BLOOMINGTON HISTORIC PRESERVATION COMMISSION

Thursday May 8, 2014

AGENDA

701-703 SOUTH WOODLAWN

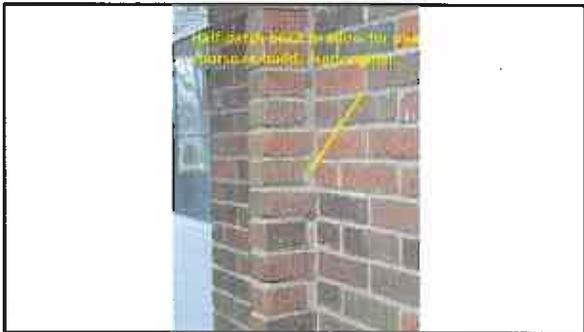
The matching rear porches were rebuilt, at some time in the past using a single wythe of bricks. The owner was attempting to rectify the weakness of the structure by rebuilding it on the same structural template as the front porches. The

foundations were not removed and the existing roofs were supported. There will be no stylistic changes other than brick laying pattern. The bricks themselves were salvaged from a previously demolished garage on the site. See attached documentary photographs.

COUNTRYMAN + MANSFIELD HOUSE
910 / 920 W. SMITH AVENUE
BLOOMINGTON, IN
JAMES ROSENBERGER, ARCHITECT
334-8932

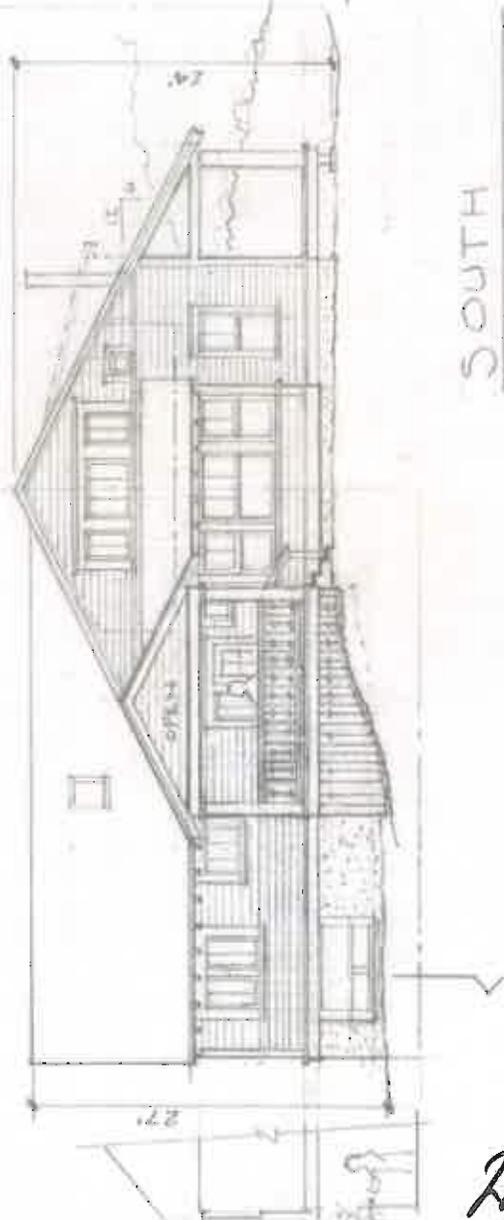
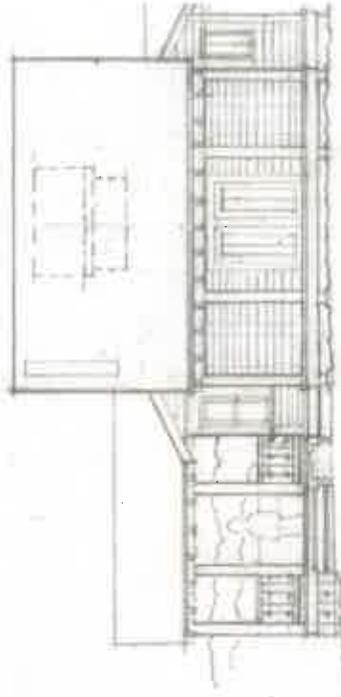
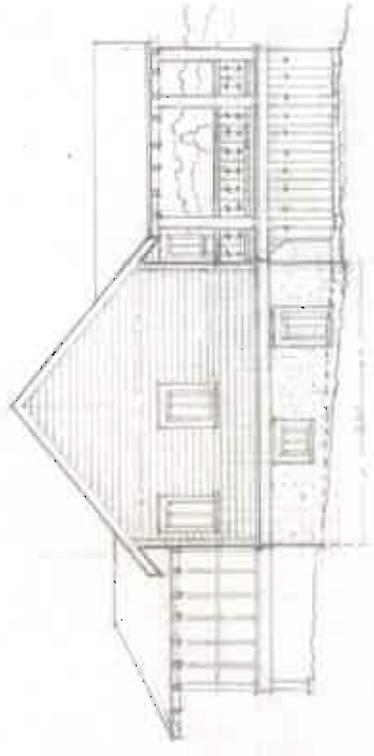
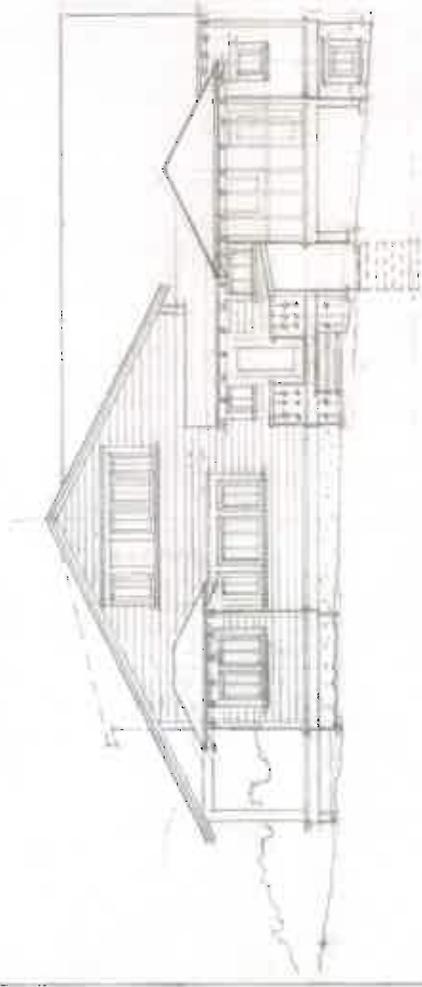
It is the overall appearance of the house that makes this plan successful. The house is a traditional Craftsman bungalow, with features (porches and fenestration) that blend well into the neighborhood. Framing details will be made of cedar and the siding will be cement board, in keeping with the proportions compatible with this style. although some design decisions do not reflect the specific intent of the guidelines, this is a unique site.

The proposal is a good reflection of the needs of the client, the best interests of the neighborhood for a large undeveloped infill tract, and visual interest which reflects the grammar used in the traditional housing.

Staff recommends approval based upon the Greater Prospect Hill DG that will adopt the Conservation District new construction standards (from which this report is drafted).

WEST ELEVATION

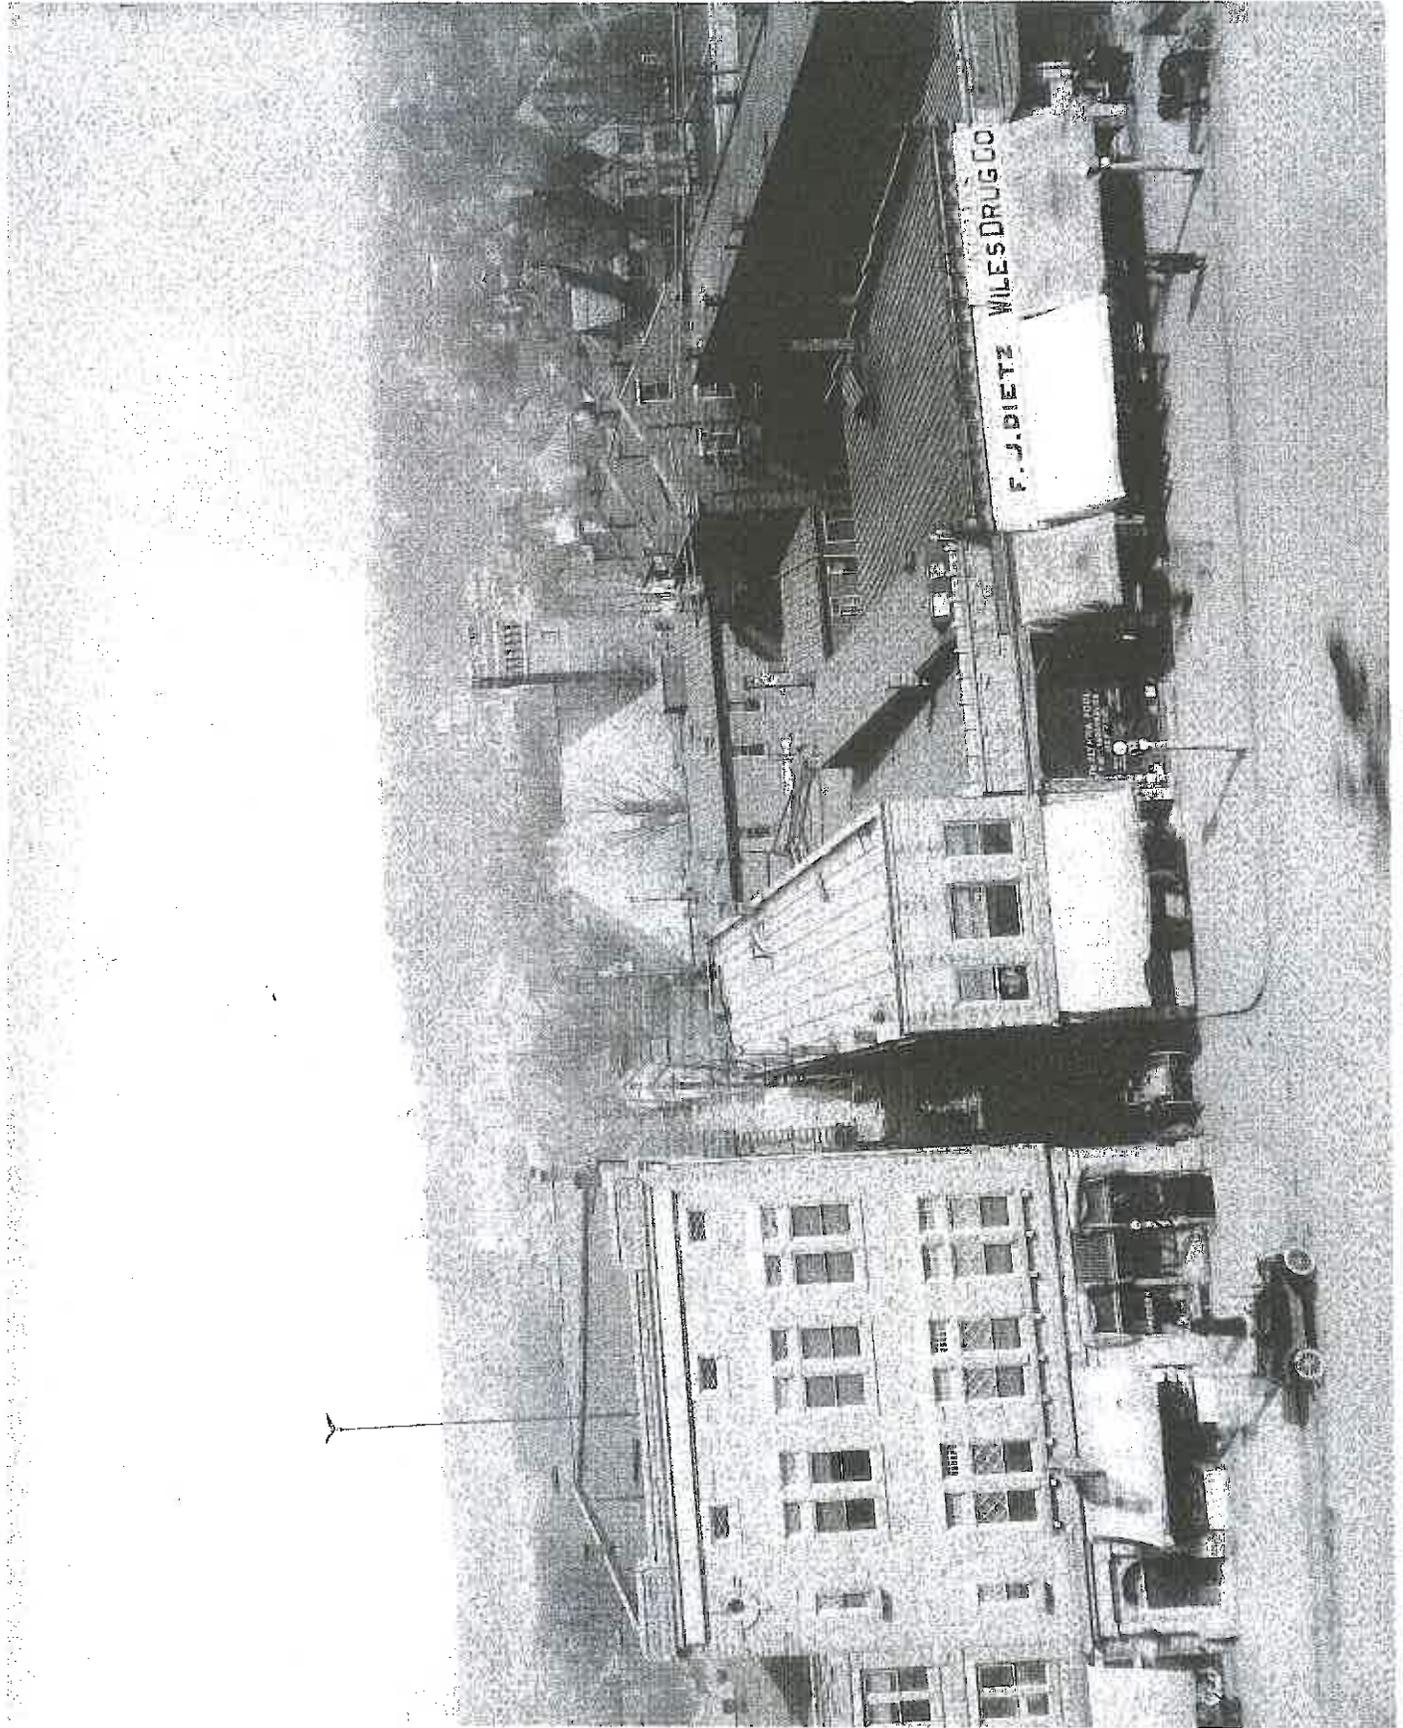
Staff visited the site and acknowledges there are factors behind the Williams facade that cause modest changes to the plans. The aluminum supports and muntins are often heavier (wider) than the original supports and it would be good to request narrower framing if it is available. The drawings do appear to be well proportioned. The owners have submitted an estimate of \$24,220 for the facade work. They request the entire \$10,000 BUEA grant.

Recently the Williams Facade was removed and did disclose serious damage to the limestone elements, but all original piers remain. The base of one of the piers has been cut. There are hole drilled into the block. Staff will report on the elected treatment of the damage as it is decided.
